**ADVISORY REPORT  
FINDINGS, CONCLUSIONS, AND RECOMMENDATIONS**

**File:** **WISTI PRELIMINARY SUBDIVISION, FILE NO. PSB12-00001**

# Wisti Subdivision PSB12-00001

**TREE RETENTION PLAN  
 INTEGRATED DEVELOPMENT PLAN  
 WISTI PLAT**

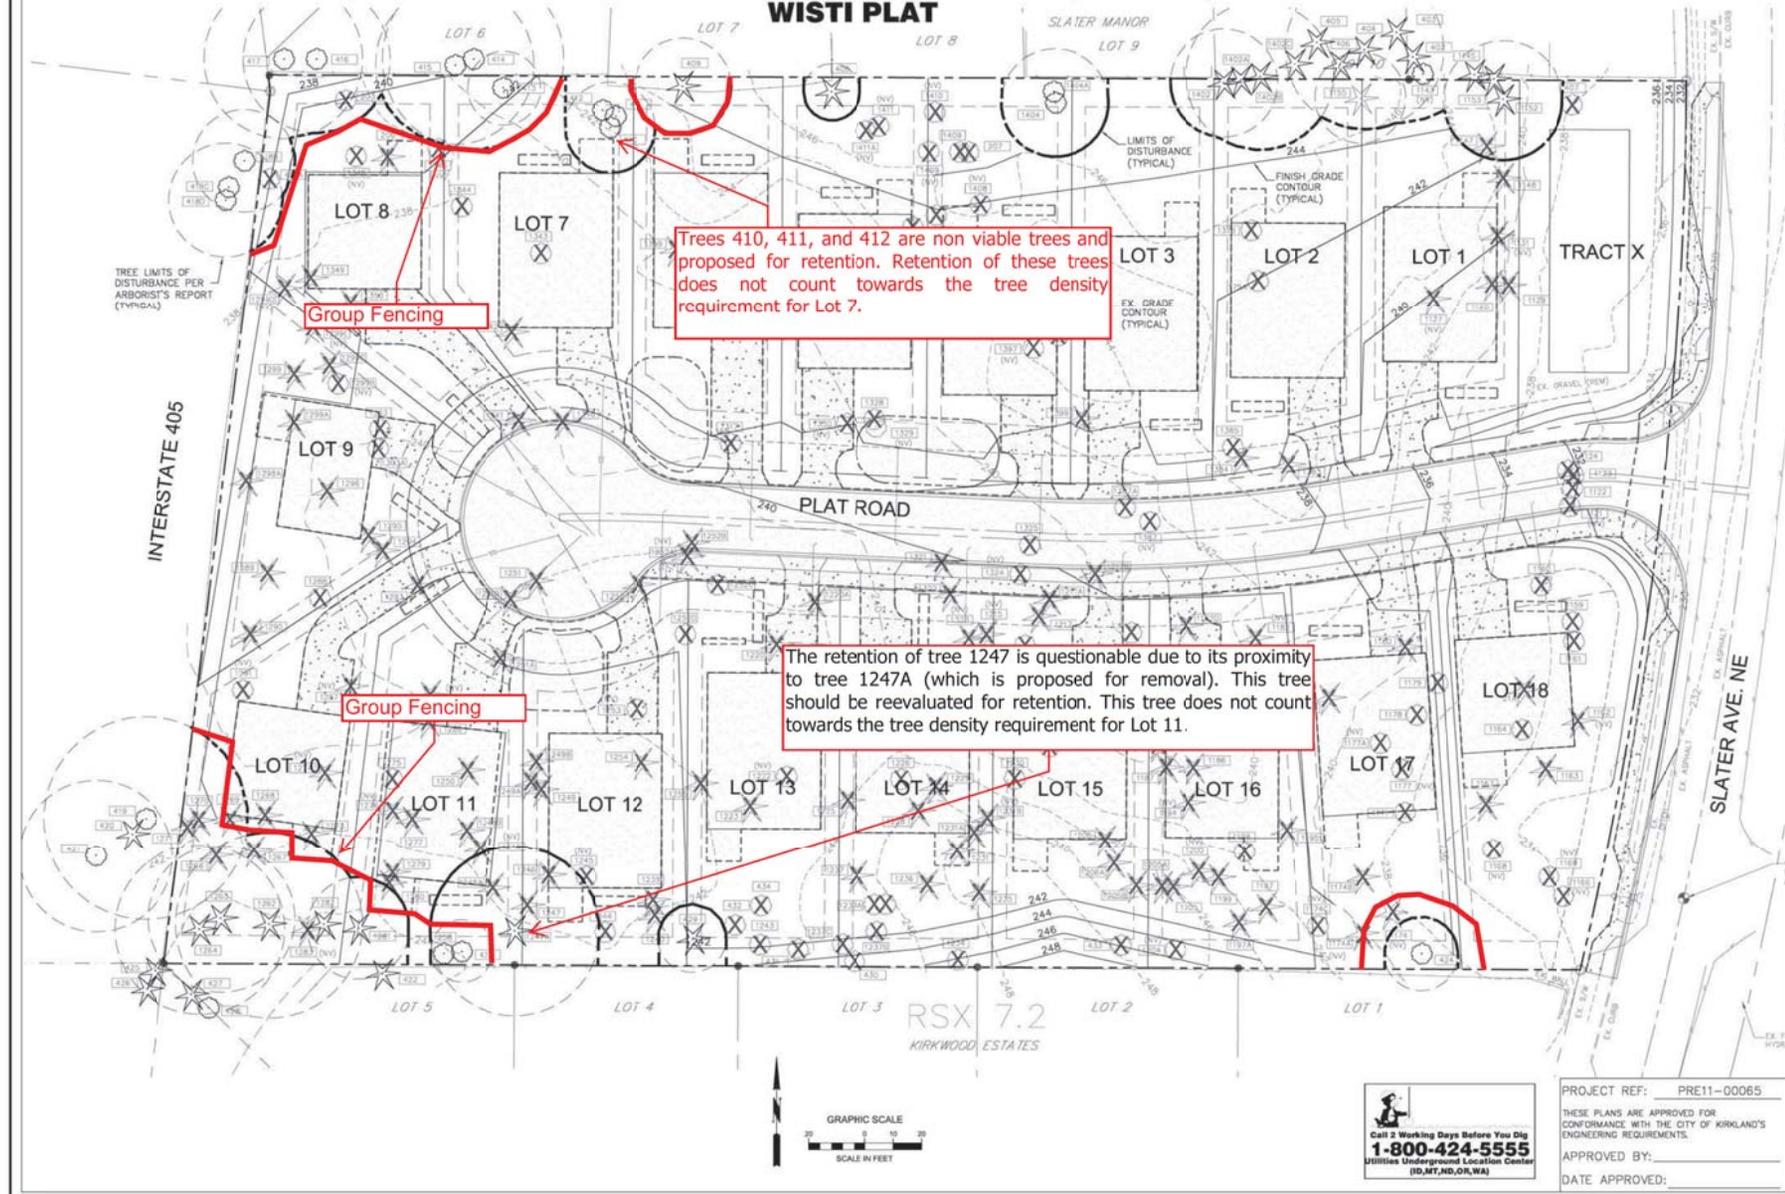
The retention of tree 1247 is questionable due to its proximity to tree 1247A (which is proposed for removal). This tree should be reevaluated for retention. This tree does not count towards the tree density requirement for Lot 11.
